KWM-380 TRANSCEIVER (622-5093-001, -101)
 HF-380 TRANSCEIVER (622-3580-001, -101)
 SYNTHESIZER VARIABLE REFERENCE
 FREQUENCY LOOP A5A2 (638-6920-001)

SERVICE BULLETIN NO 3

POTENTIAL FREQUENCY WARBLE

P/O Synthesizer Variable Reference Frequency Loop A5A2
Figure 1

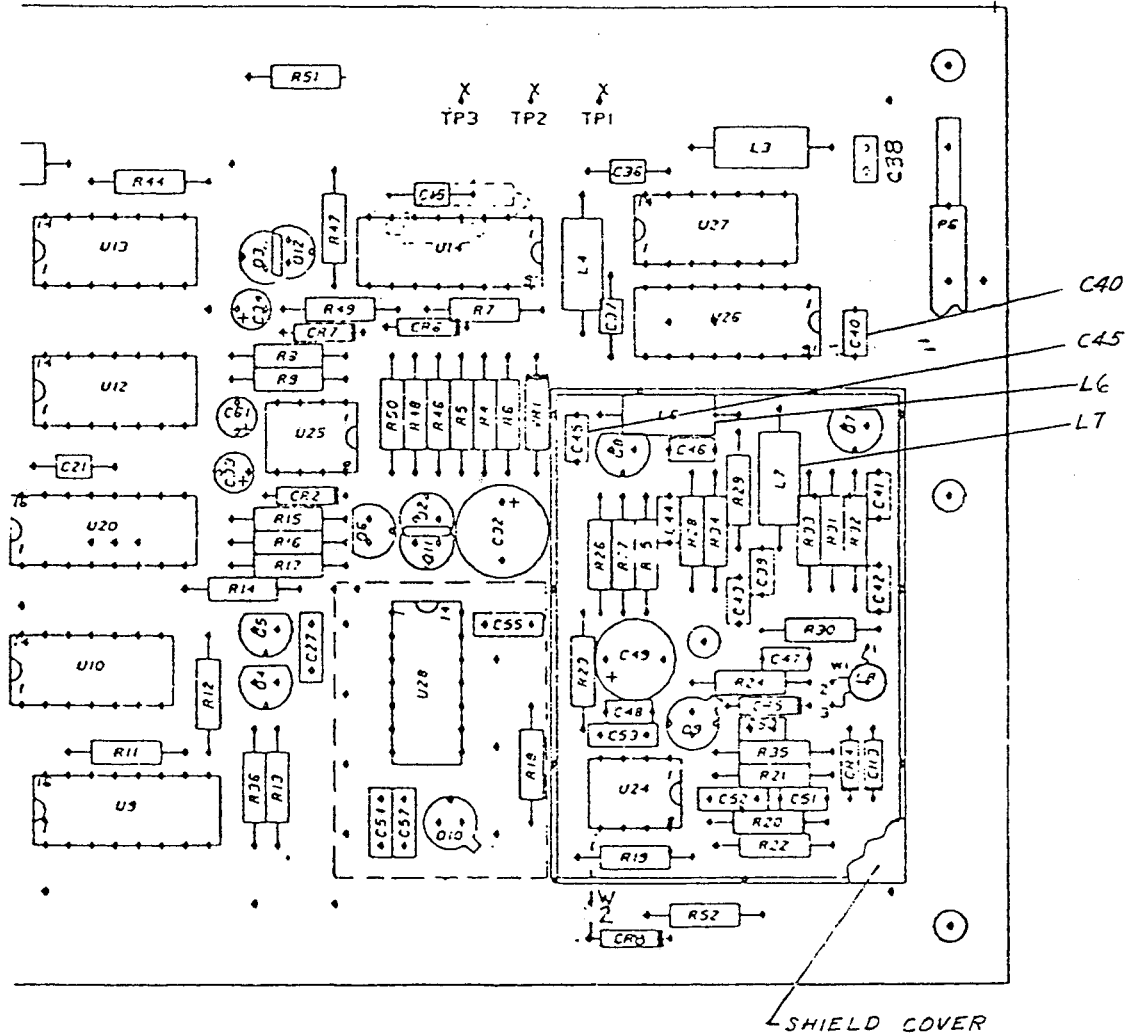
A frequency warble may occur at certain frequencies in some radios. The warble will usually occur at the top end of each 1 MHz band. The problem has been traced to two integrated circuits on synthesizer variable reference frequency loop A5A2. When U14 and U26 are at the low end of their specified parameters, a low rf input may cause them to miscount.

This modification increases the rf input levels to the integrated circuits by replacing two coils and two capacitors.

- F. Remove shield cover by removing seven screws.
- G. Remove coils L6 and L7 and replace them with new 0.15 μ H coils (240-1562-000).
- H. Remove capacitors C40 and C45 and replace them with new 4 pF capacitors (912-4141-080).
- I. Mark RWK REV G on the A5A2 card.
- J. Reassemble the transceiver in the reverse order of disassembly.
- K. Mark SB 3 on the service bulletin information chart. If the transceiver does not have an information chart, install a chart (280-3778-010) near the nameplate.
